SERVICE BULLETIN

N° 189-296

ATA 21 - HEATING DUCT REAR AVIONIC BAY INSPECTION

This Service Bulletin is issued in order to give the required instruction to improve the installation of the Heating System Duct P/N 70688A010001 through the application of the Retromod P/N 8G2140P02111 and to, contemporarily, prescribe a one-off inspection for condition of this duct.

Figure 1

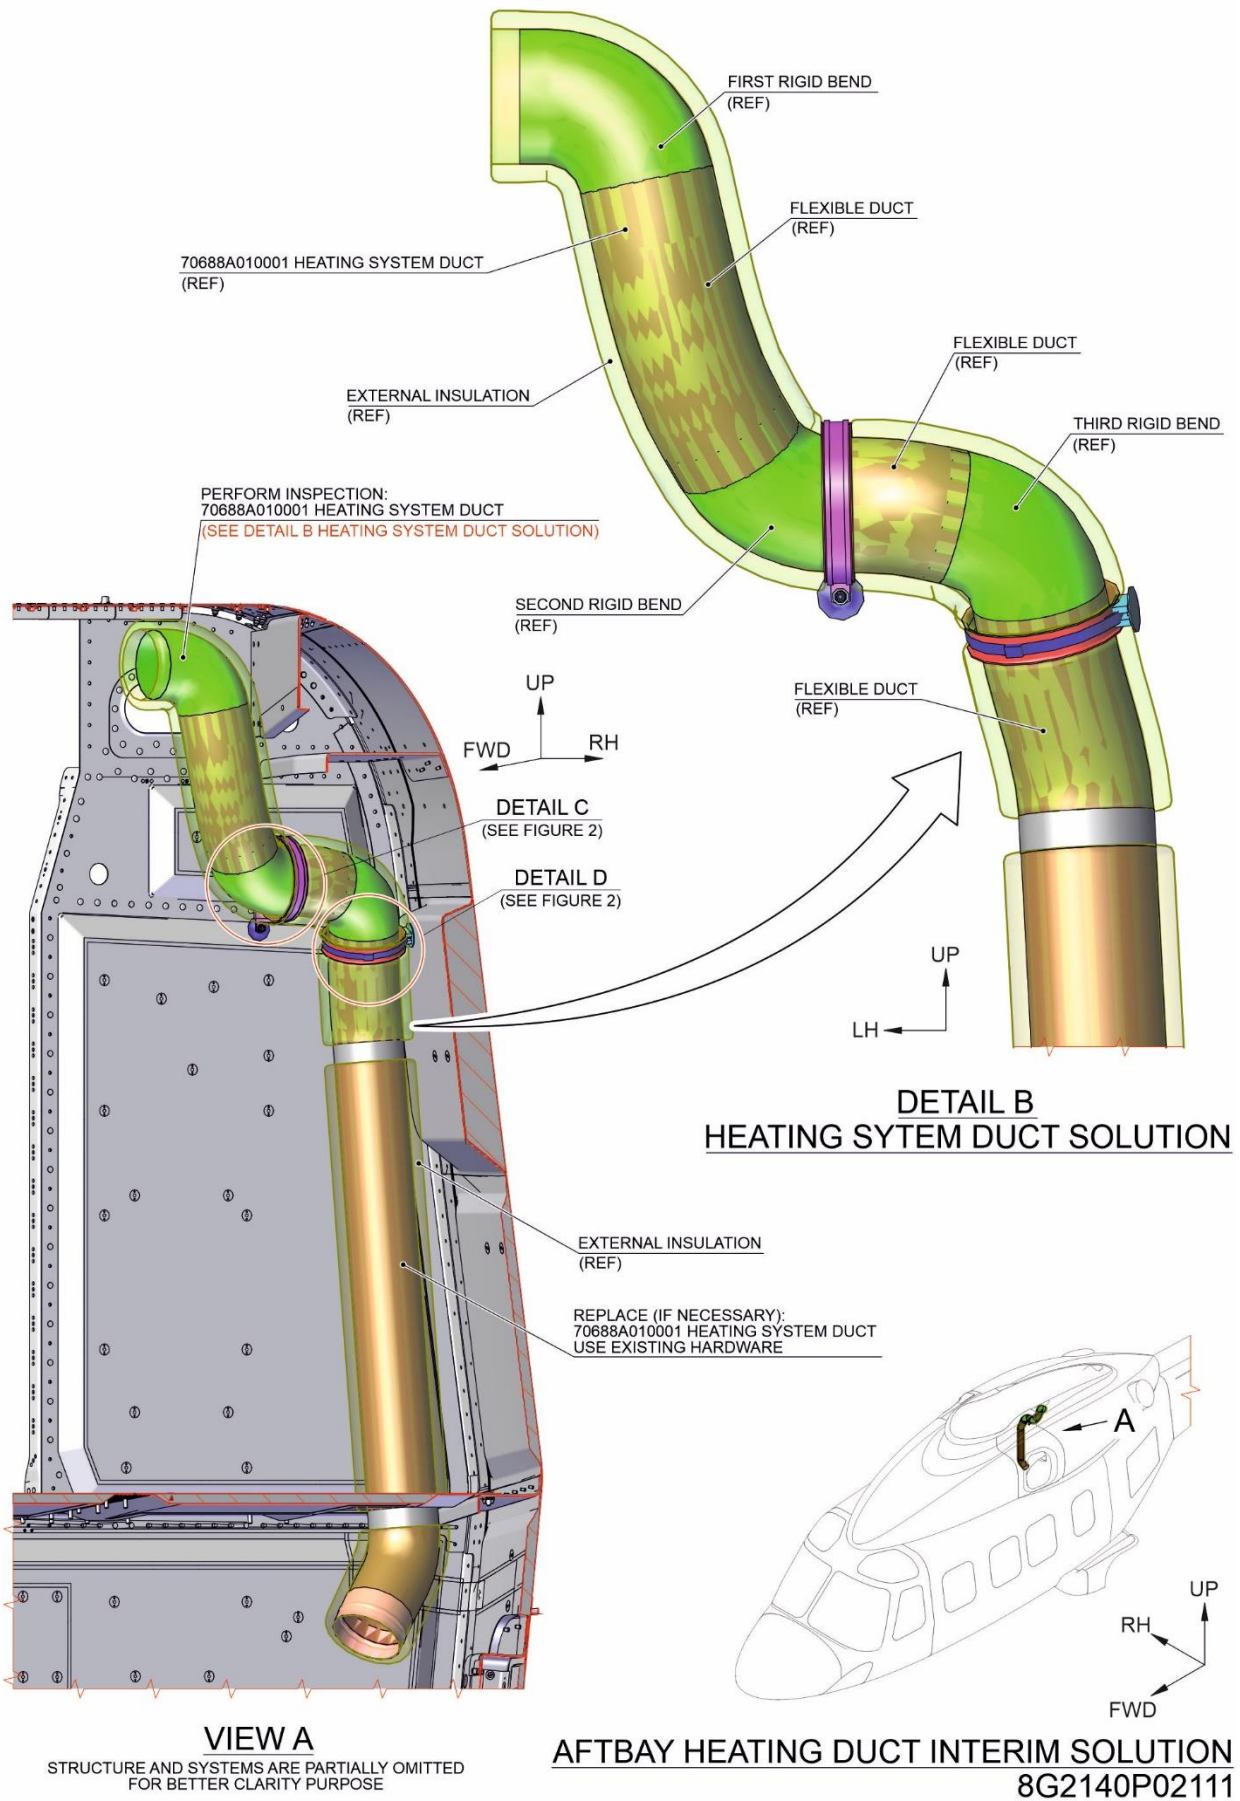
3. With reference to Figure 1, perform the visual inspection of the heating system duct P/N 70688A010001 as described in the following procedure:
 - 3.1 With reference to Figure 1 View A, check the external surface of the duct P/N 70688A010001 for condition. In case of finding, take a picture of the damaged area and contact Product Support Engineering (engineering.support.lhd@leonardocompany.com) to receive further instructions.

- 3.2 With reference to Figure 1 Detail B, check the joints by touch between the second

and third rigid bends with the adjacent flexible ducts for any relative movement / rotation (no movement / rotation is allowed). In case of findings, take a picture of the damaged area and contact Product Support Engineering (engineering.support.lhd@leonardocompany.com) to receive further instructions.

Figure 2

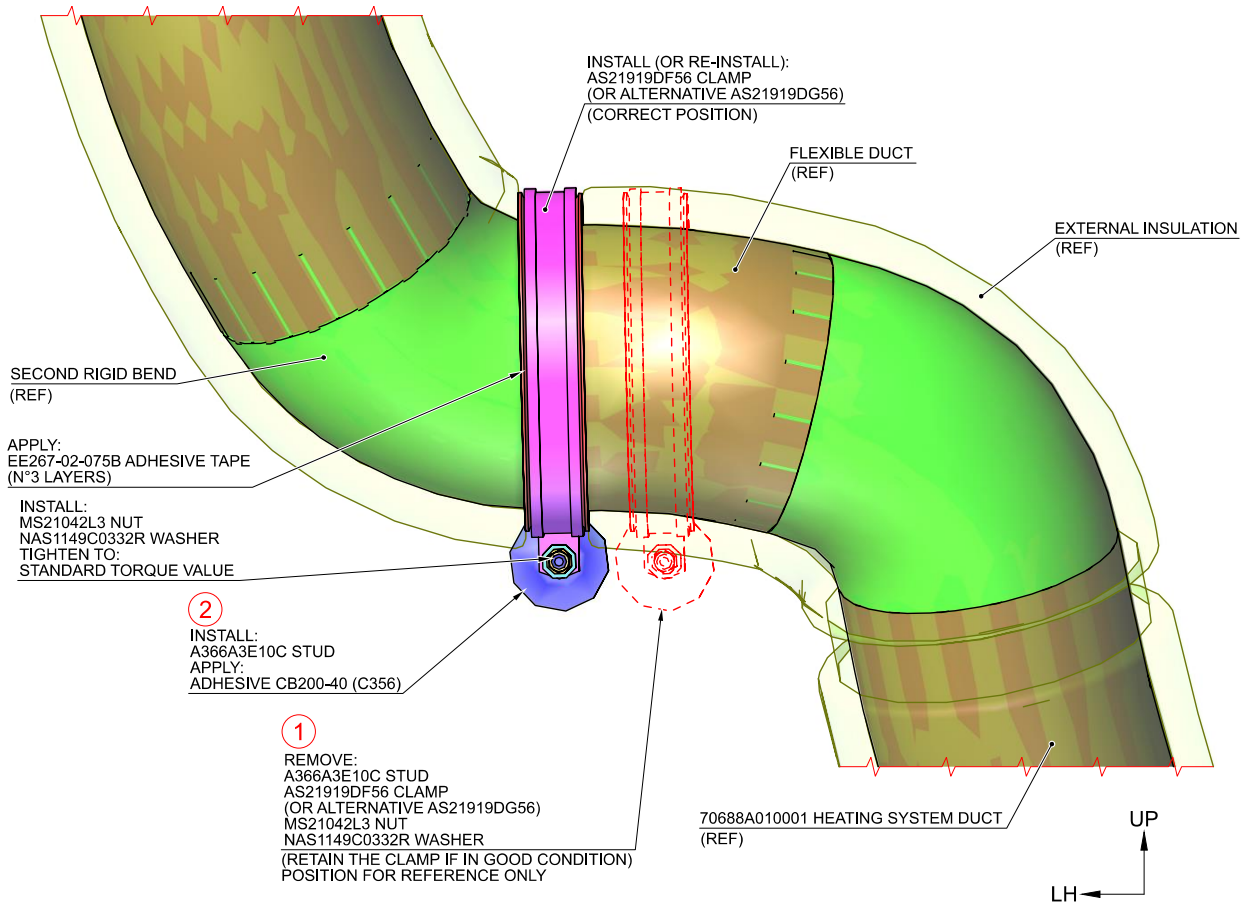
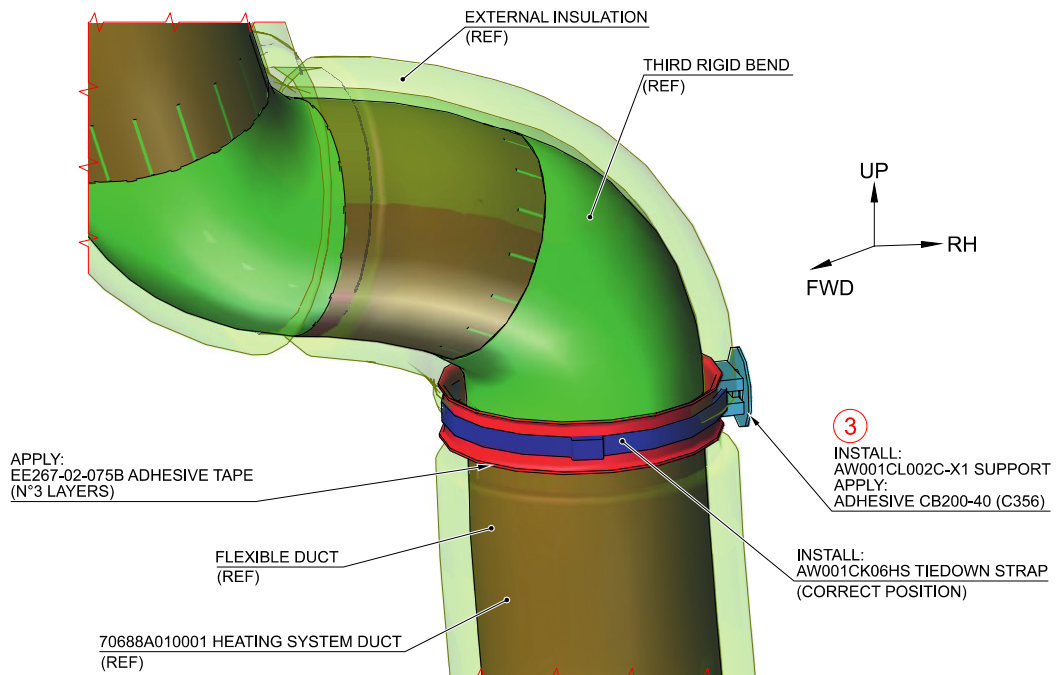
5. With reference to Figure 2 Detail C, check the position of the existing P-clamp P/N AS21919DG56 as follows:
 - 5.1 Check, by gently compressing by hand, if the clamp P/N AS21919DG56 is installed correctly at the end of the second rigid bend (between the second rigid bend and the flexible duct at location 2). If the clamp is NOT correctly installed proceed with following step 5.2, otherwise go to step 6.

- 5.2 With reference to Figure 2 Detail C, remove the clamp P/N AS21919DG56, the nut P/N MS21042L3 and the washer P/N NAS1149C0332R from the heating system duct P/N 70688A010001 at location n°1. Retain the clamp, the nut and the washer for later reuse if in good condition.

- 5.4 With reference to Figure 2 detail C, identify the location 2 on the second rigid bend (between the second rigid bend and the flexible duct) by gently compressing the duct by hand and mark the position on the second rigid bend by using three layers of adhesive tape P/N EE267-02-075B.

- 5.5 With reference to Figure 2 Detail C, temporarily locate the clamp P/N AS21919DG56 on the taped area and countermark the location 2 of the stud P/N A366A3E10C on the panel.
- 5.6 In accordance with AMP DM 89-A-20-10-16-02A-920A-A and with reference to Figure 2 Detail C, install the new stud P/N A366A3E10C on the panel at location 2 by means of the adhesive CB200-40 (C356).
- 5.7 In accordance with AMP DM 89-A-20-00-00-00A-711A-A and with reference to Figure 2 Detail C, install the clamp P/N AS21919DG56 on the heating system duct P/N 70688A010001 at location n°2 by means of the nut P/N MS21042L3 and the washer P/N NAS1149C0332R. Tighten the nut to the standard torque value.
6. With reference to Figure 2 Detail D, install the tiedown strap P/N AW001CK06HS on the third rigid bend only as described in the following procedure:

- 6.1 With reference to Figure 2 detail D, identify the location 3 on the third rigid bend (between the third rigid bend and the flexible duct) by gently compressing the duct by hand and mark the position on the third rigid bend by using three layers of adhesive tape P/N EE267-02-075B.
- 6.2 With reference to Figure 2 Detail D, temporarily locate the new tiedown strap P/N AW001CK06HS on the taped area and countermark the location 3 of the support P/N AW001CL002C-X1 on the panel.

- 6.3 With reference to Figure 2 Detail D, install the new support P/N AW001CL002C-X1 on the panel at location n°3 by means of the adhesive CB200-40 (C356).
- 6.4 With reference to Figure 2 Detail D, install the tiedown strap P/N AW001CK06HS on the heating system duct P/N 70688A010001 at location 3.

Figure 3

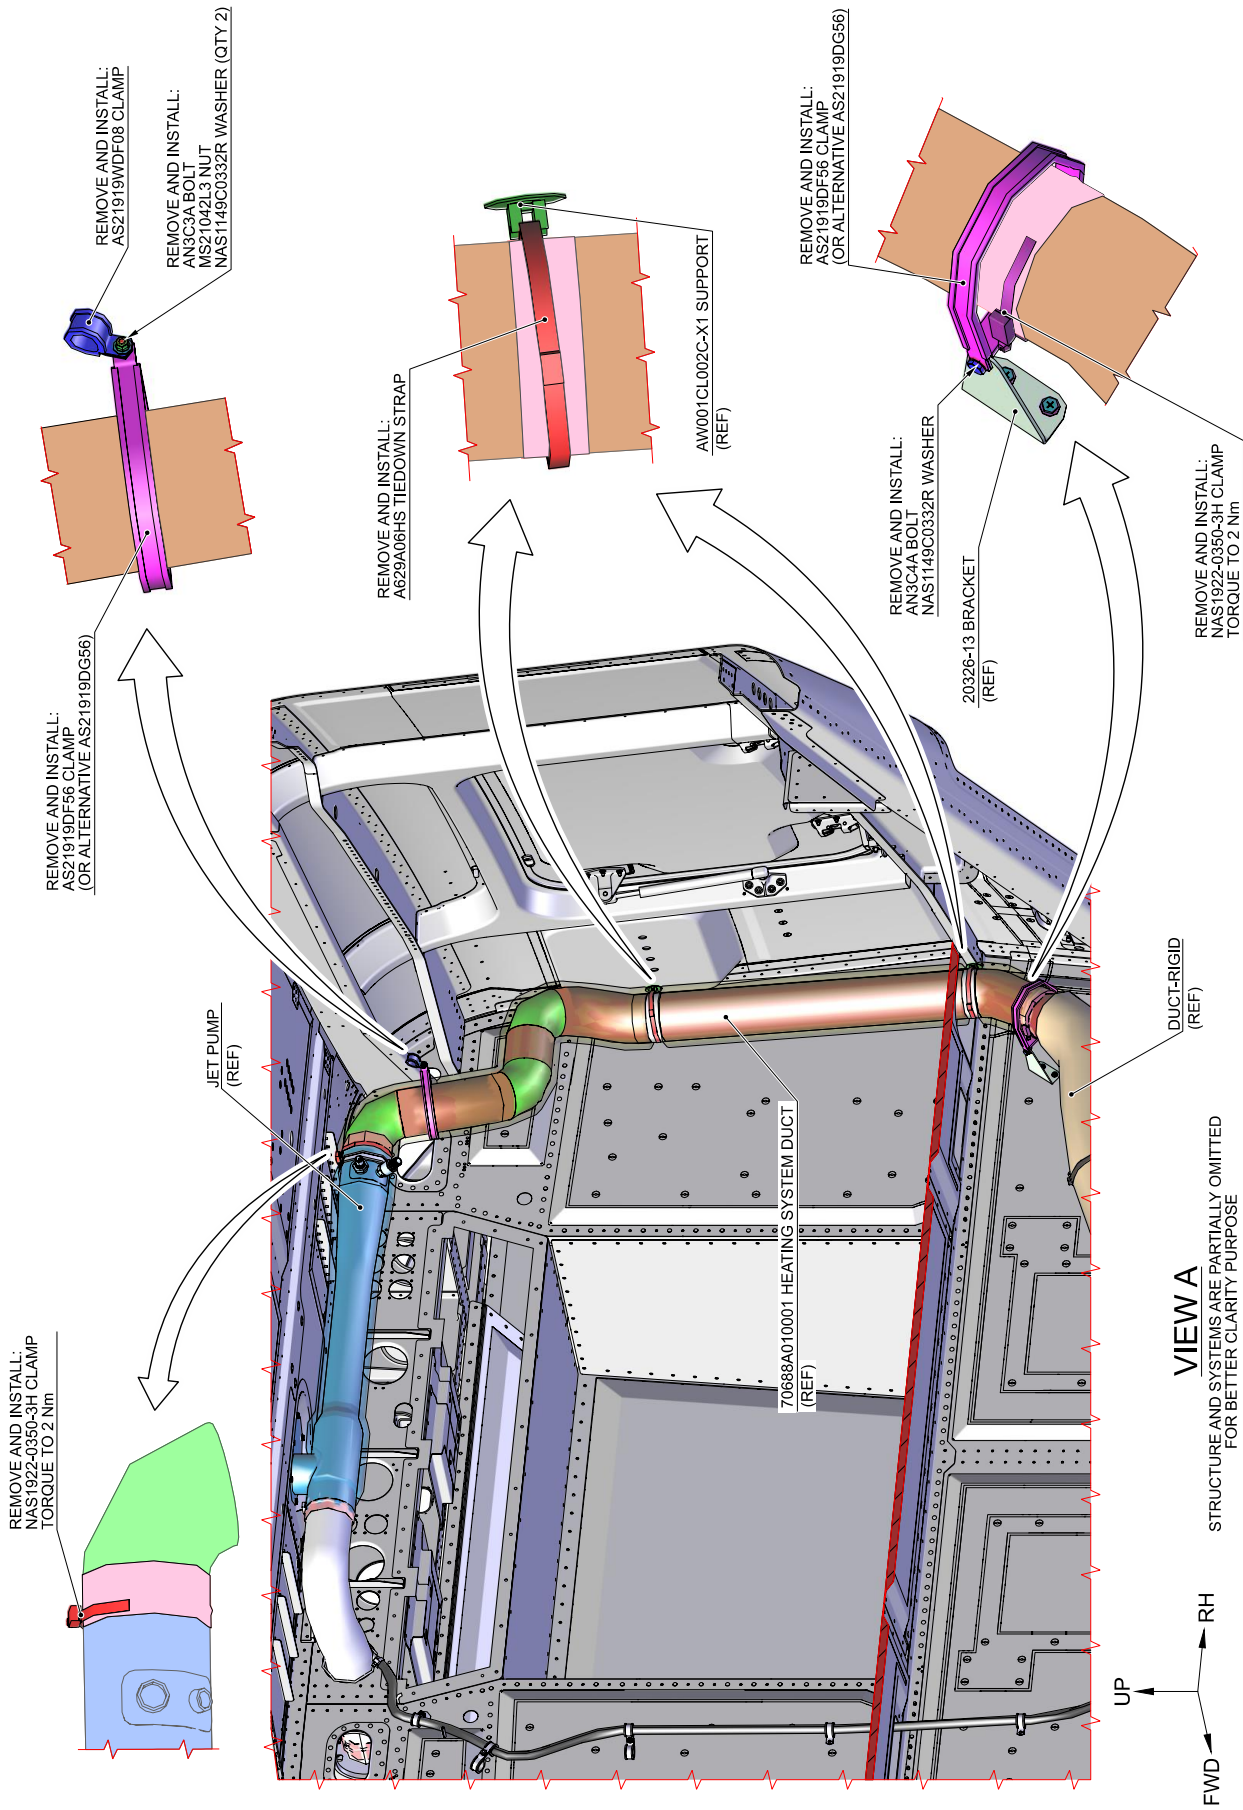
4. Perform a detailed inspection of the inner surface of the duct P/N 70688A010001 as follows:
 - 4.1 In accordance with applicable steps of AMP DM 89-A-21-40-09-00A-520A-A and with reference to Figure 3:

- 4.2 Insert the boroscope through the exposed inlet of the duct and check the bonding between the second and third rigid bends with the adjacent flexible ducts for condition (no separation is allowed). In case of any finding, take a picture of the damaged area and contact Product Support Engineering (engineering.support.lhd@leonardocompany.com) to receive further instructions.

- 7.1 In accordance with applicable steps of AMP DM 89-A-21-40-09-00A-520A-A and with reference to Figure 3 View A, remove the clamp P/N NAS1922-0350-3H that connects the duct to the jet pump and carefully move away the duct from the jet pump.

- 7.2 With reference to Figure 3 View A, remove the bolt P/N AN3C3A, the nut P/N MS21042L3, n°2 washers P/N NAS1149C0332R and clamps P/N AS21919DG56 and P/N AS21919WDF08.

- 7.3 With reference to Figure 3 View A, remove n°2 tiedown strap P/N A629A06HS.
 - 7.4 With reference to Figure 3 View A, remove the bolt P/N AN3C4A, the washer P/N NAS1149C0332R, the clamp P/N AS21919DG56 and the clamp P/N NAS1922-0350-3H from the heating system duct.

- 7.8 With reference to Figure 3 View A, install the clamp P/N AS21919DG56 and the

clamp P/N AS21919WDF08 by means of the bolt P/N AN3C3A, the nut P/N MS21042L3 and n°2 washers P/N NAS1149C0332R. Tighten the nut to the standard torque value.

- 7.9 With reference to Figure 3 View A, install n°2 tiedown straps P/N A629A06HS on the heating system duct.
- 7.10 With reference to Figure 3 View A, install the clamp P/N AS21919DG56 to the bracket by means of the bolt P/N AN3C4A and the washer P/N NAS1149C0332R.
